TENNESSEE VALLEY AUTHORITY

Enclosed is TVA's response to NRC requests for information concerning the potential for liquefaction of soils at the Watts Bar Nuclear Plant site. Included are responses to NRC questions 362.29 through 362.35 provided by R. L. Tedesco's letter to H. G. Parris dated March 30, 1981 and question 362.36 provided by R. L. Tedesco's letter to H. G. Parris dated May 7, 1981.

Question 362.29 (2.5.4)

FIGURE Q362.35-3

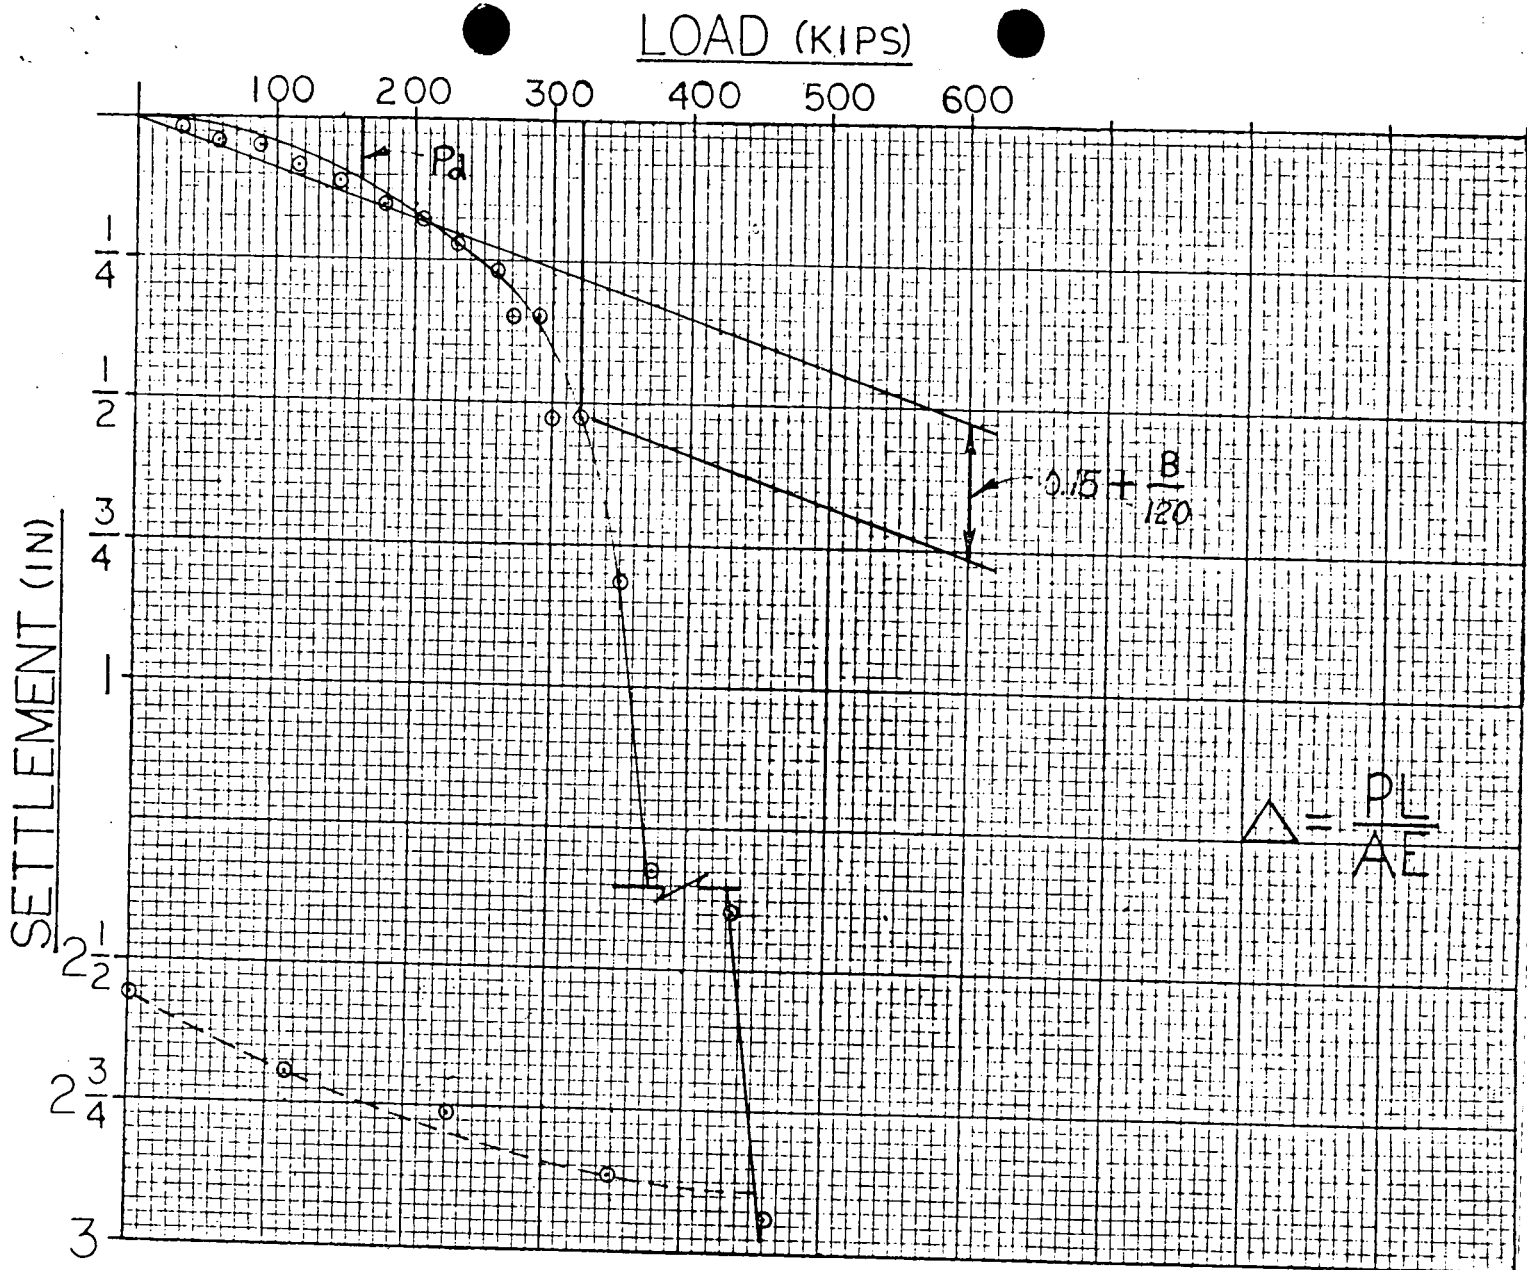
- (a) quantitative and procedural details of the pile load tests conducted to verify the adequacy of installed piles. Provide the design loads, test loads, the location of test piles, comparison of soil conditions at the location of test piles and the piles installed under the ERCW pipe slabs and load test results.
- (b) up-to-date time vs settlement plots at various locations of the slabs where settlements are being monitored. Tabulate the values of the measured maximum differential settlement of the slabs and evaluate its effect on the allowable stress levels in these slabs.

Results of the pile load tests are presented in the form of settlement versus load plots. These graphs are shown on figures Q362.35-3 through -6. Design loads and test loads are found in table Q362.35-1.

PILE NO. 1
 HP 12x53
 VULCAN HAMMER
 $P_d = 160 \text{ K}$
 $\sigma_{PILE} = 10.2 \text{ KSI}$

One-Dimensional Soil Profile Used for Liquefaction Evaluation

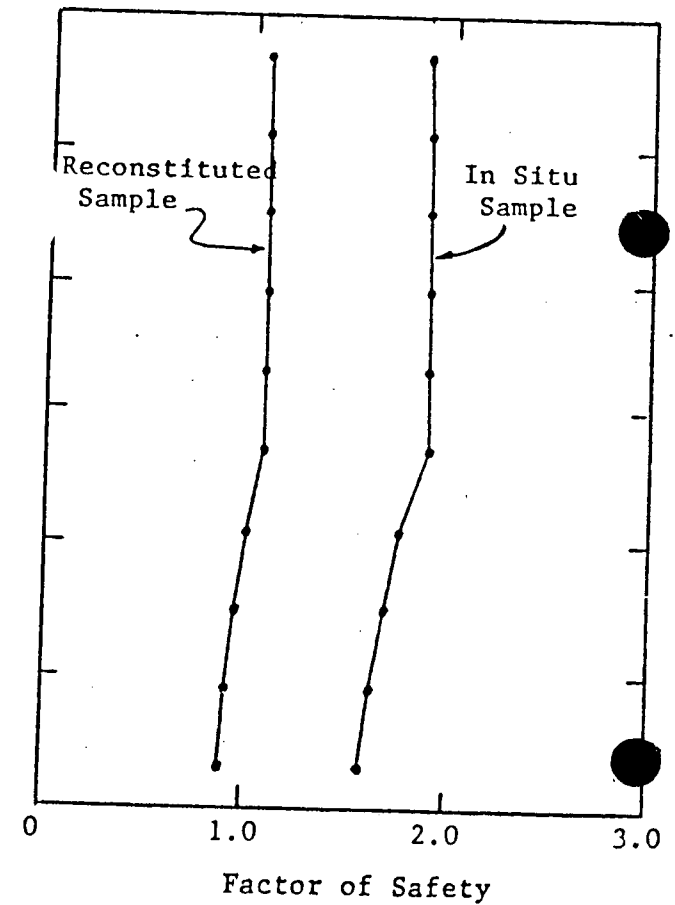
- (a) The cross-section of the one dimensional soil profile analyzed. Indicate the water table elevation used in the analysis. Discuss any conservatism in selecting the profile.

5. (a) The profile selected and analyzed is based on boring SS-50-1. This boring is shown in Figure Q362.27-1. This boring contained the most SM Material. Surface elevation is 716.9 feet. Around elevation 685 and 690 the blow count increases to +50 and is identified as "top of weathered shale." This is assumed as "top of rock" for the liquefaction evaluation. Thus the depth of the profile is 30 feet. The water table is about 15 to 20 feet below the ground surface in boring SS-50, SS-50-1, SS-65, and SS-65-1. Thus the water table is assumed to be 15 to 20 feet below the ground surface. The profile analyzed is fairly typical of those along the ERCW route. This generalized soil profile is shown graphically in Figure Q362.36-11.

Comparison of Induced Shear Stress (τ_{avg}) and Shear Stress Required to cause 5% strain (τ_f) and Resulting Factors of Safety with Depth Below Ground Surface.

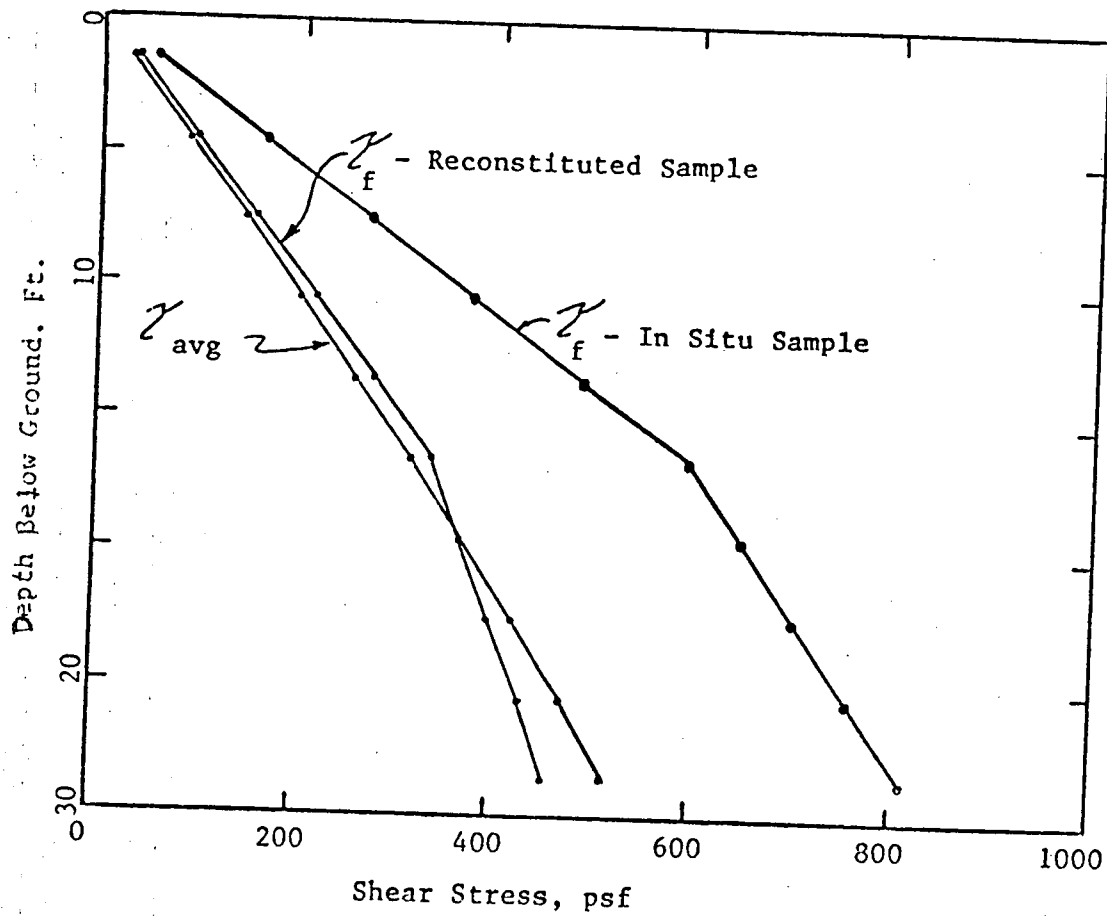
- (g) Provide a table of factors of safety for the alluvial material at various depths against liquefaction potential.

we conservatively have 5 cycles of uniform load for a magnitude 5.5 to 6.0 event. Factors of safety against the development of 5 percent strain are given in Tables Q362.36-2 and Q362.36-3 and Figure Q362.36-12. These factors of safety are calculated only for seismic loading case 1. Results are presented for cases where the water table is not considered and where it is located 16.5 feet below the surface. The 16.5 is in the upper range as given in the borings and the exact number 16.5 is chosen for convenience only. Factors of safety are calculated for both the reconstituted sample (sample No. 3) and for the in situ sample (sample No. 2). The in situ sample is more representative of field behavior. It should be repeated that these factors of safety are against the development of 5 percent strain and not against actual liquefaction which, if it occurs, occurs at strains in excess of 10 percent for the samples tested.
